8.1 DA 2016/744 - 64 Allens Parade - Modification to Consent.DOC

S96	64 ALLENS PARADE	
	LENNOX HEAD	
PROPOSED SECTION 96 TO APPROVED NEW DWELLING DA N ^o : 2016/744		
DRAWING SCHEDULE		
	No	NAME
S96		
	01	LOCATION PLAN/ SITE PLAN & DRAWING LIST
	02	PLANS
	03	SECTIONS
	04	ELEVATIONS

Sketch showing accurate encroachments on building envelope

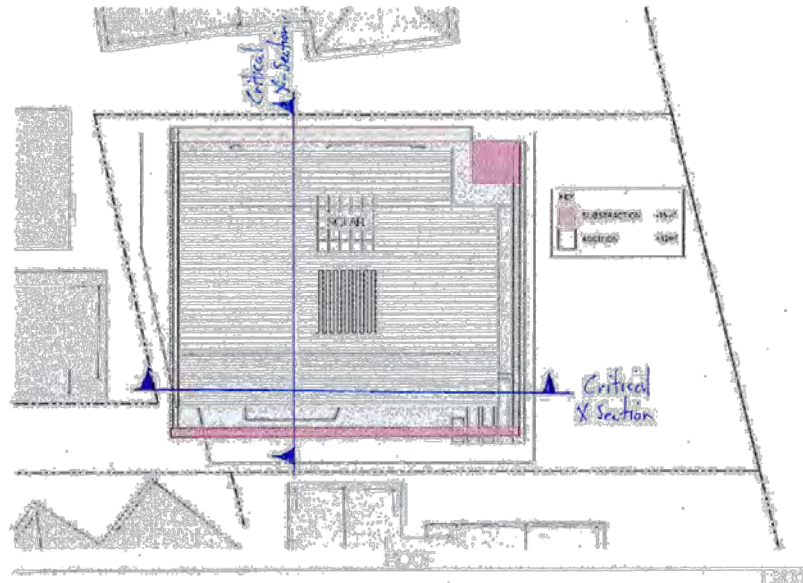
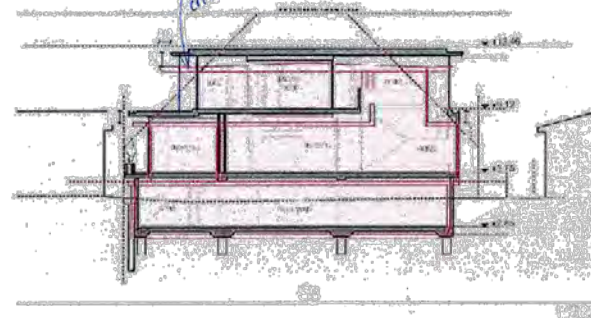
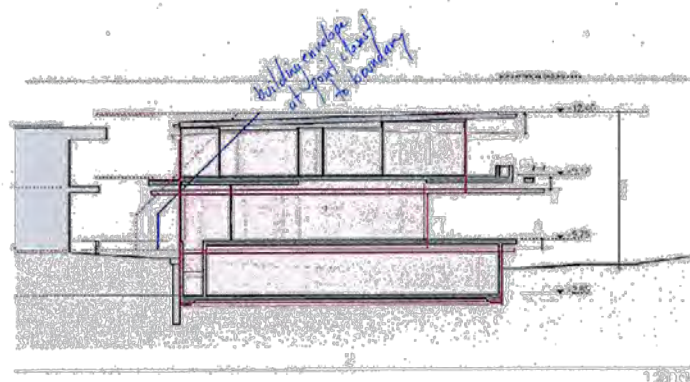
6. The building envelope overlays on the plans at Appendix B supporting the application are misleading. It does not include the critical cross section showing the maximum encroachment upon the envelope by the first-floor bedroom on the southern side and also grossly misrepresents the western boundary building envelope encroachment which is at its maximum in the south western corner.

1. Set the basement back 1,265mm from the boundary so as to be located within the building footprint in accordance with Councils policies;
2. Remove all encroachments of the building envelope along the southern side. This would require removal of the eaves and relocation of the southern bedroom wall approximately 1.0m northwards.

Sketch showing
Corrected Building Envelope
Encroachments.
23/6/18.

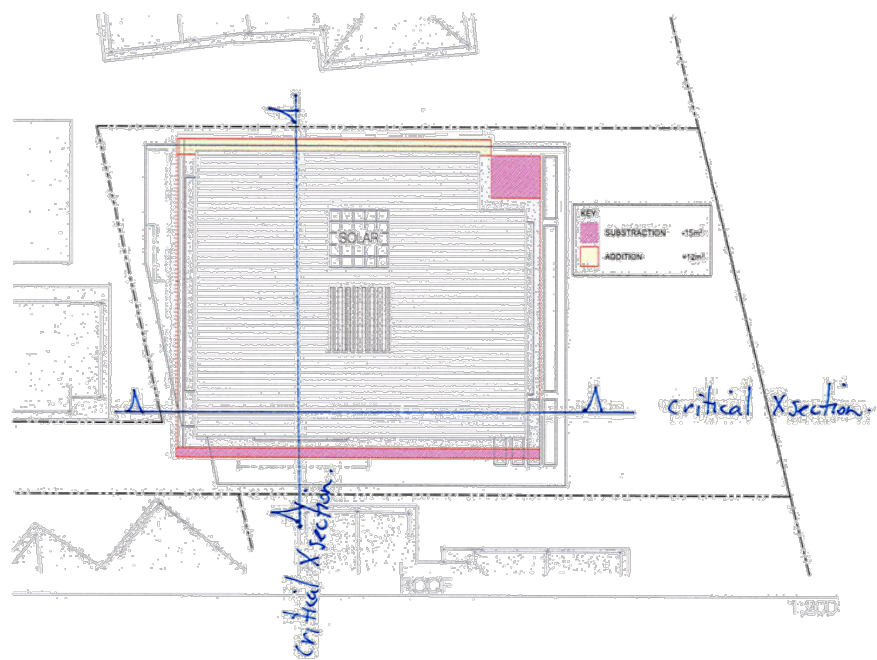
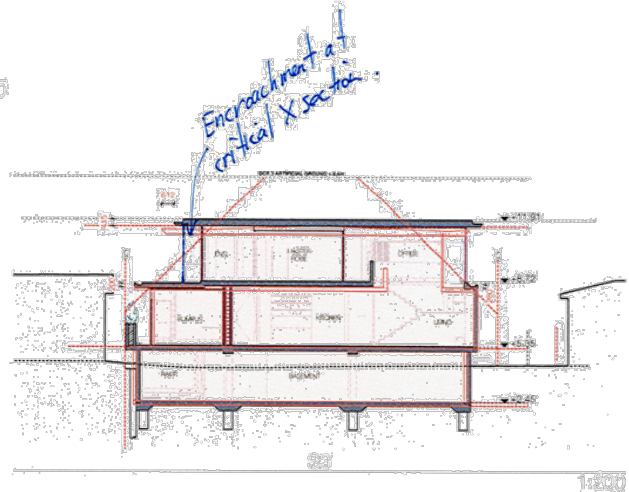
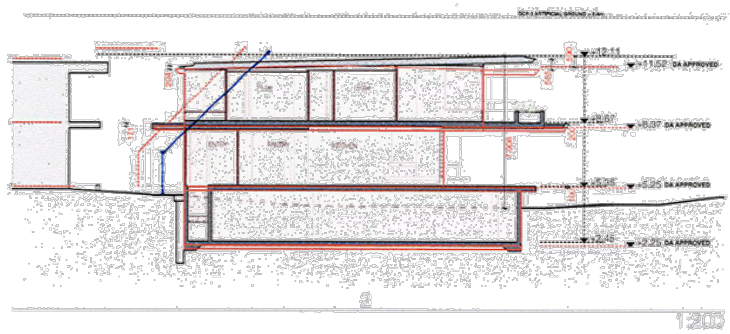
Attachment: Sketch of Corrected Envelope Encroachments
